Channel Operating Margin (COM) for CDAUI-8 chip-to-chip interfaces

Adam Healey, Avago Technologies
Cathy Liu, Avago Technologies

IEEE P802.3bs 400 GbE Task Force
November 2015

- Table 120D-7 is incomplete (comment #53)
- This presentation contains a proposal to complete the table

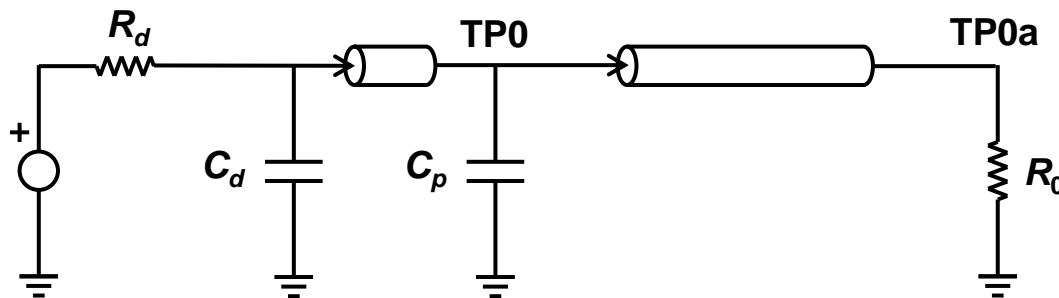
- Define TBD device package and termination parameters
 - Begin with $R_d = 40 \Omega$, $C_d = 280 \text{ fF}$, $C_p = 110 \text{ fF}$
 - In addition, change transmission line Z_c (Table 93A–3) to 90Ω
- Change $b_{\max}(1)$ from 1 to 0.5
 - Larger values appear to be unnecessary
- 2-stage receiver equalizer (replaces Equation 93A–22)

$$H_{ctf}(f) = \left[\frac{10^{g_{DC}/20} + j f / f_z}{1 + j f / f_{p1}} \right] \left[\frac{10^{g_{DC2}/20} + j f / f_{z2}}{1 + j f / f_{p2}} \right]$$

- $f_z = f_{p1} = f_b / 2.5$, $g_{DC} = -15$ to 0 in 1 dB steps
- $f_{z2} = f_{p2} = f_b / 40$, $g_{DC2} = -4$ to 0 in 1 dB steps

Channel #4
 $z_p = 30$ mm

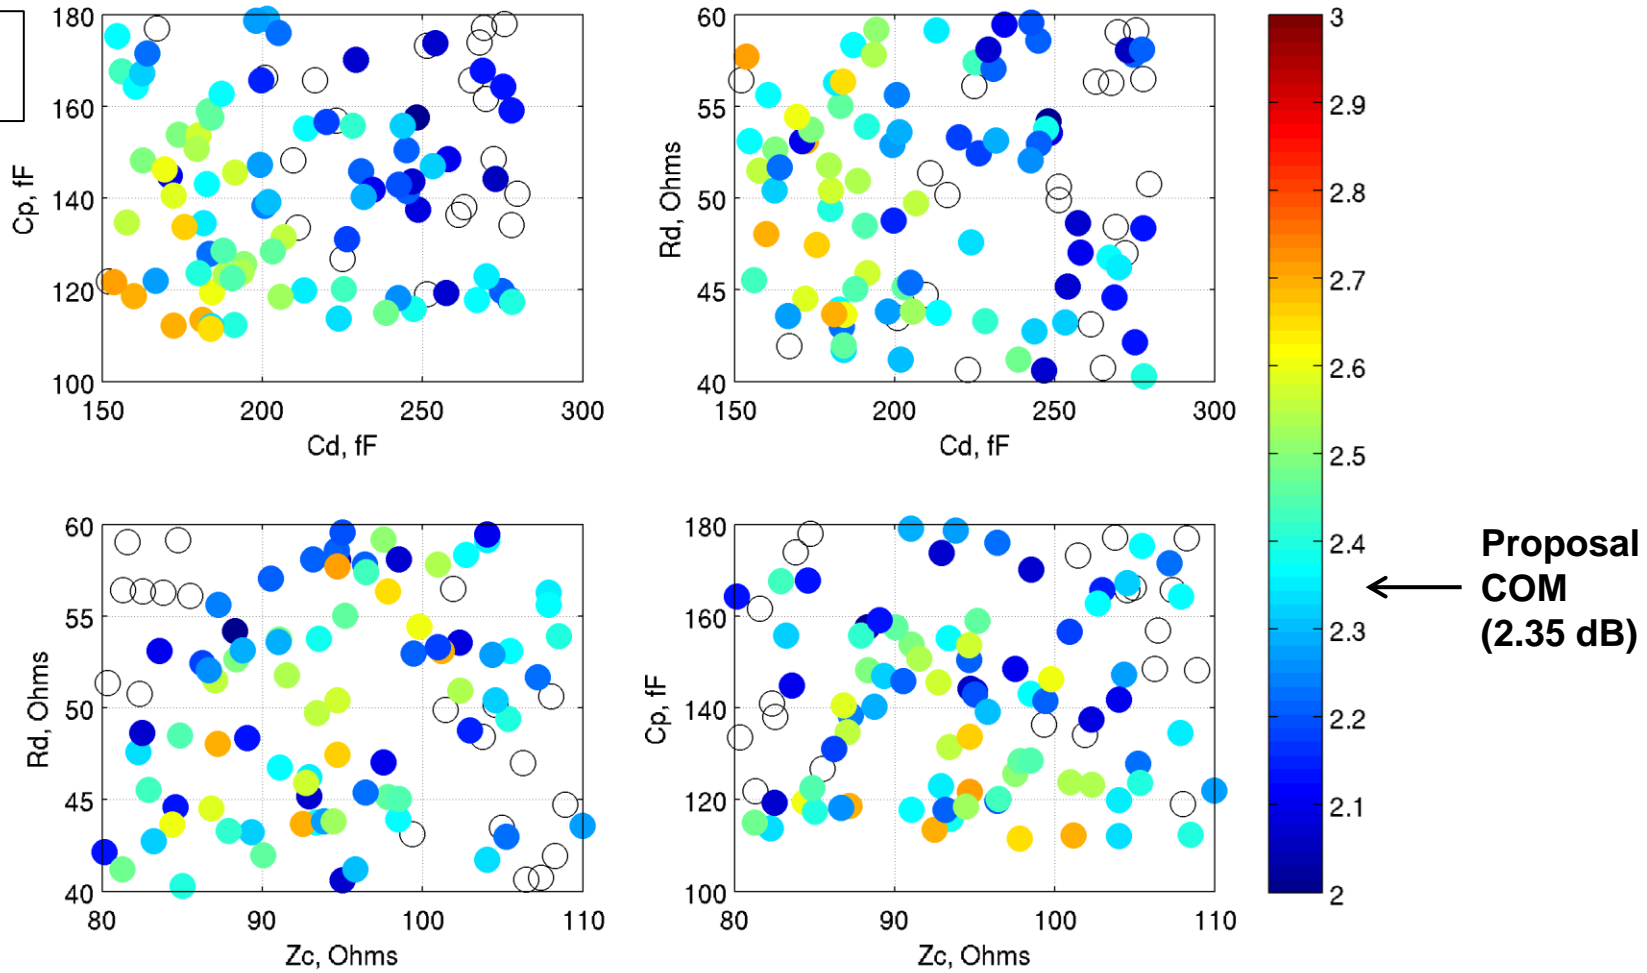
- 100 trials with uniformly distributed R_d , C_d , C_p , and Z_c values
- Many combinations result in COM similar to or better than proposal
